Rezoning Transportation Analysis

Petition Number: #2022-037

General Location Identifier: 15302513, 15302514, 15302510, 15302519, 15302512

Revision Log:

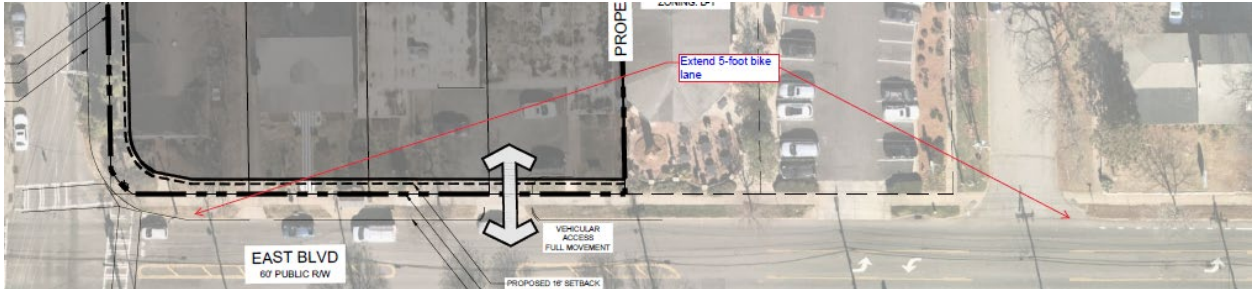
3. **Right-of-Way:**

- a. **East Boulevard:** Revise site plan and conditional note(s) to commit to dedicate 42-feet of right-of-way from the road centerline.
- b. **Scott Avenue:** Revise site plan and conditional note(s) to commit to dedicate 35.5-feet of right-of-way from the road centerline.

The site plan shall label and dimension the right-of-way from the road centerline.

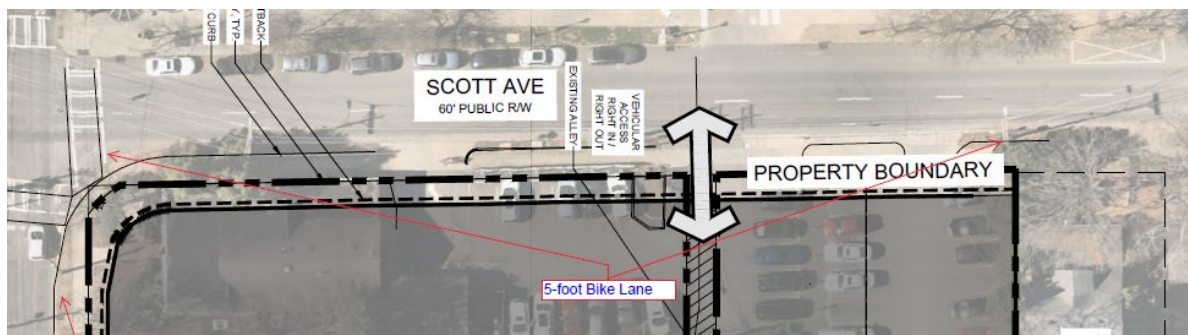
6. Revise site plan and conditional note(s) to commit to widen Scott Avenue and provide a 5-foot bike lane across the site's frontage.

Note added (8/23/22) The petitioner has requested to restripe the existing travelway to match the Scott Avenue typical section south of East Blvd (5-ft bike lane without a buffer) if the existing travelway can geometrically accommodate the existing on-street parking, 2-thru lanes and a 5' bike lane. Comment to remain until addressed or until CDOT evaluates and approves request.
